水務署
Water Supplies Department

**Approval of "KOHLER" Sensor Mixer
(General Acceptance No. C20230596)**

Details of Fitting: 3/8" Deck mounted sensor mixer

Model: K-13468H-YY
(where "YY" denotes the code of colour finish)

K-13468H-YY

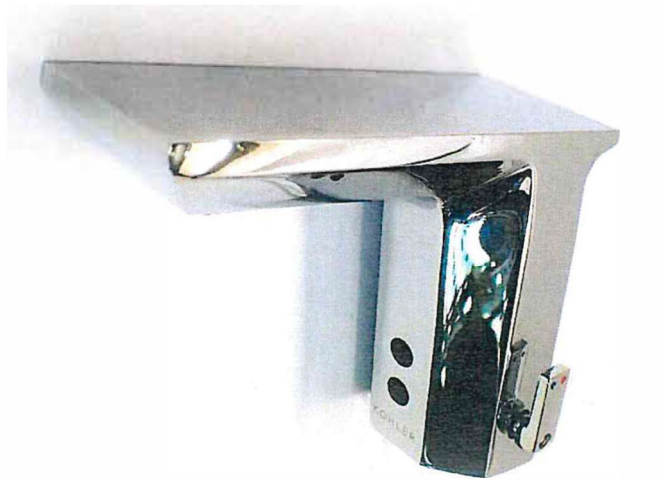
This Authority hereby permits the use of the above fitting in fresh water plumbing systems subject to full adherence to Waterworks installation requirements. In particular, you are required to draw your customers' attention to the following requirement-

"The cold water supply to the fitting shall be drawn from the same source that supplies the hot water apparatus so as to provide a balanced pressure and to obviate the risk of scalding in the event of a restriction or failure in the water supply."

"A stop cock or gate valve must be installed at the upstream of the fitting for manual isolation of water supply." AND

"The main voltage operated sensor valve should comply with the electricity safety regulation for applications in bathroom, toilet etc."

A condition of this acceptance is that the fitting to be installed shall be replicas of the sample as certified by the testing agent mentioned above and without modifications. This acceptance may be withdrawn at any time if the standard of the fitting installed fails to meet that of the approved sample or if the fitting is found to be unsuitable for use in fresh water plumbing systems.

This acceptance is only applicable to the main body of the fitting, unless otherwise specified.
